## CALIFORNIA COASTAL COMMISSION

### STAFF REPORT: REGULAR CALENDAR

APPLICATION NO.: 4-96-207

PROJECT DESCRIPTION: Construct a 2 story, 25.5 ft. high (above natural grade), 3,600 sq. ft. single family residence with a detached 480 sq. ft. 2 car garage, retaining walls, grouted rock swale, and septic system. No grading.

EXHIBIT NO. 4
APPLICATION NO.
4-96-207 (ITZAKI)
LANDSCAPE + FUEL MODIFICATION PLAN

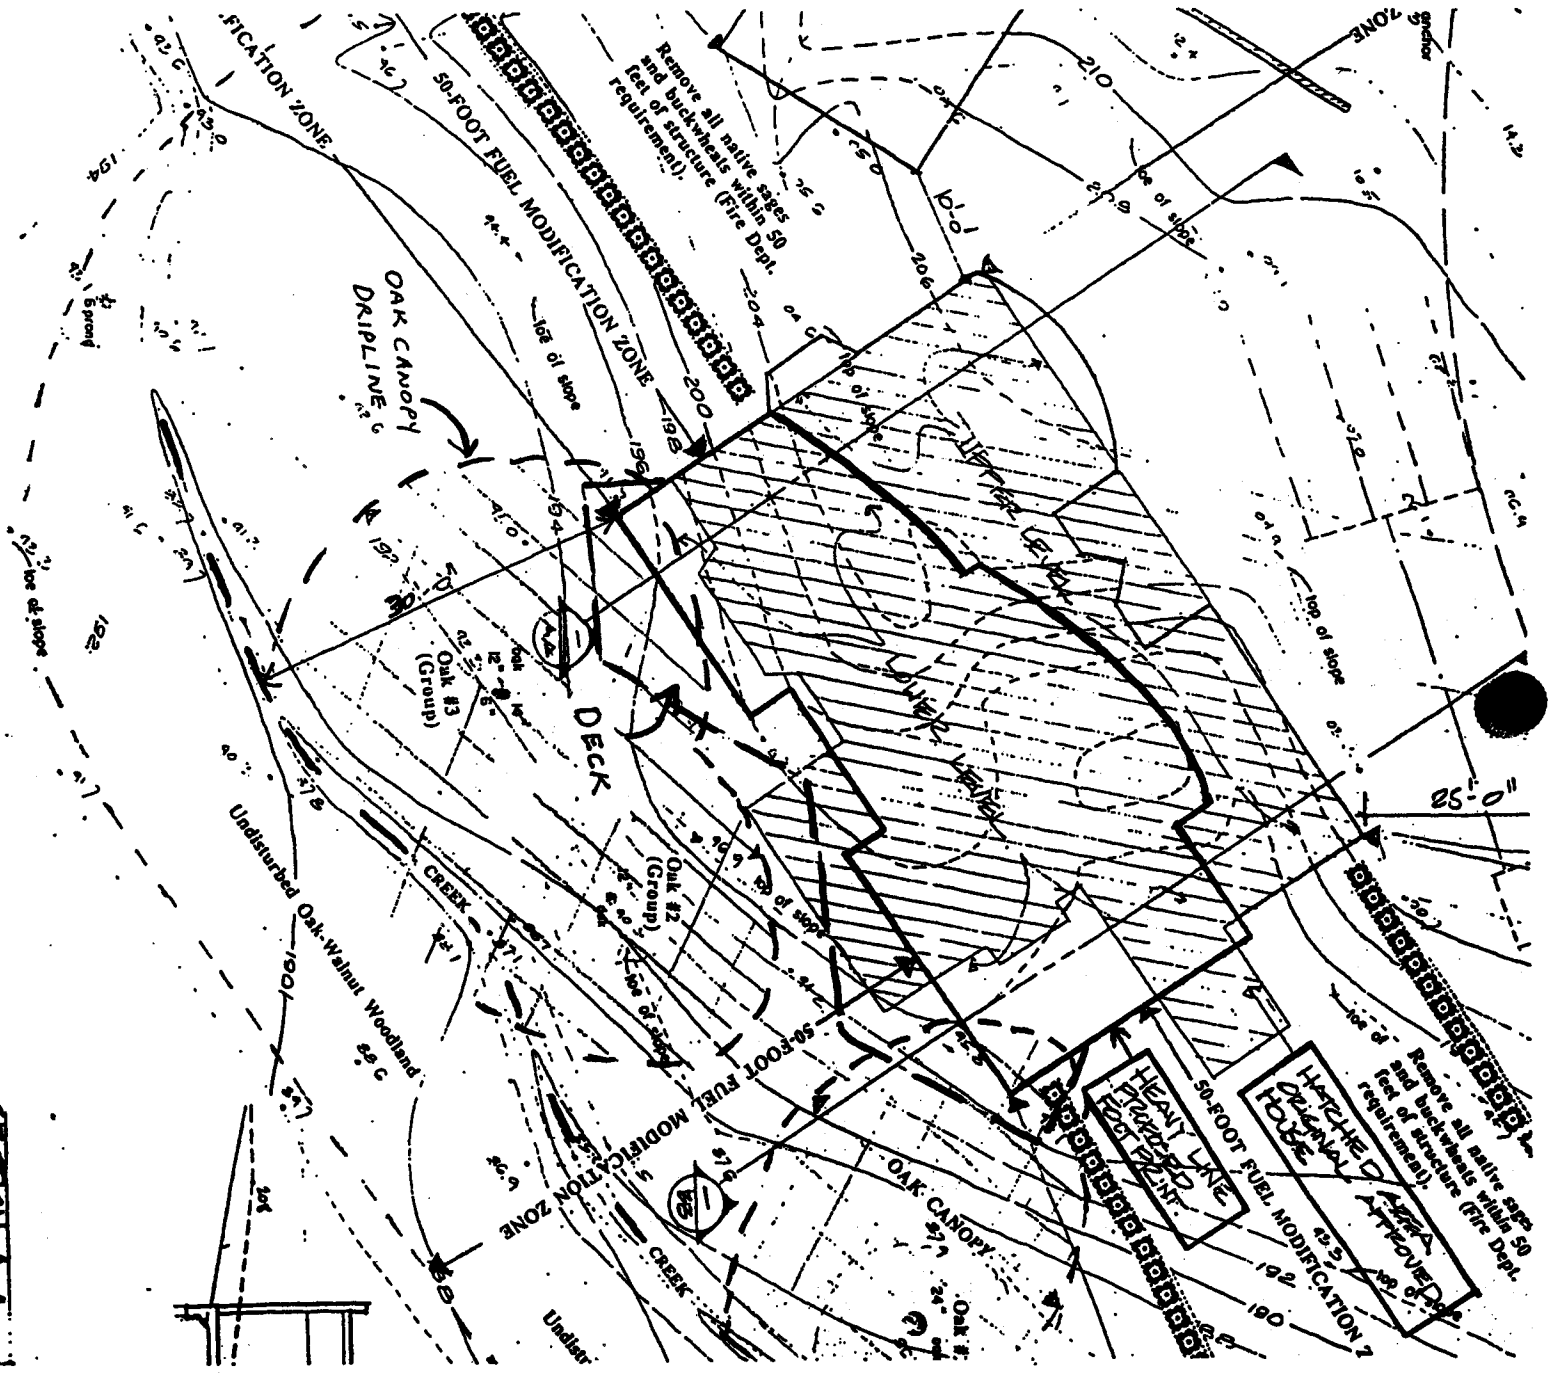
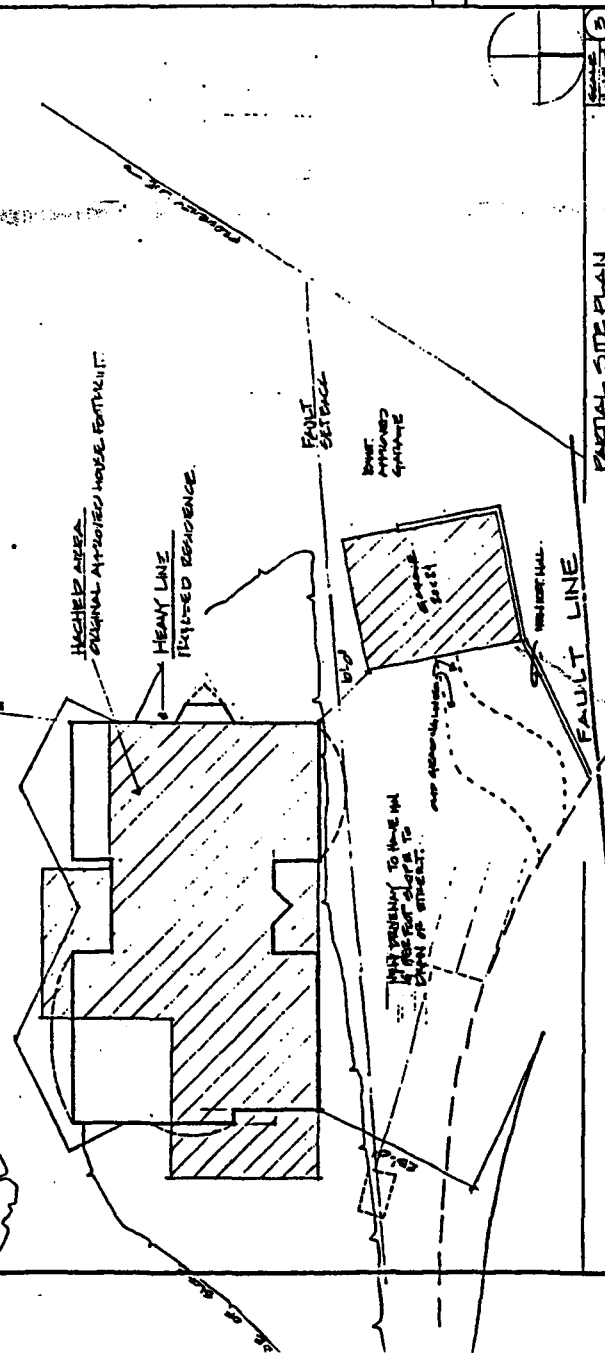
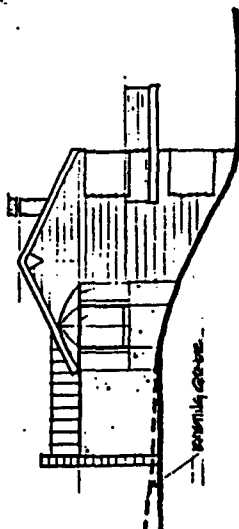
Prior to the issuance of the coastal development permit, the applicant shall submit revised site and floor plans for the review and approval of the Executive Director, which illustrate the proposed residential structure and attached decks are sited outside of the dripline of the oak tree canopy, as shown on the landscape and fuel modification plan dated 5/14/97 (Exhibit 4).

In addition, the proposed decks attached to the residence extend a maximum of 8 feet into the dripline of the oak trees and two corners of the residence extend a maximum of 5 feet into the dripline of the oaks. This encroachment into the sensitive dripline area of the oak trees will damage these trees over time. Although the site is constrained by the creek, required road setbacks and the septic system there is sufficient area on the site to relocate the residence or redesign the residence and decks to avoid the dripline of the oak trees. Therefore, the Commission finds that in order to protect the oaks along this disturbed riparian corridor it is necessary to require the applicant to submit revised site and floor plans which illustrate the proposed residence and attached decks are setback outside of the dripline of the oak tree canopy as shown on the Landscaping and fuel modification plan dated 5/14/97 (Exhibit 4).
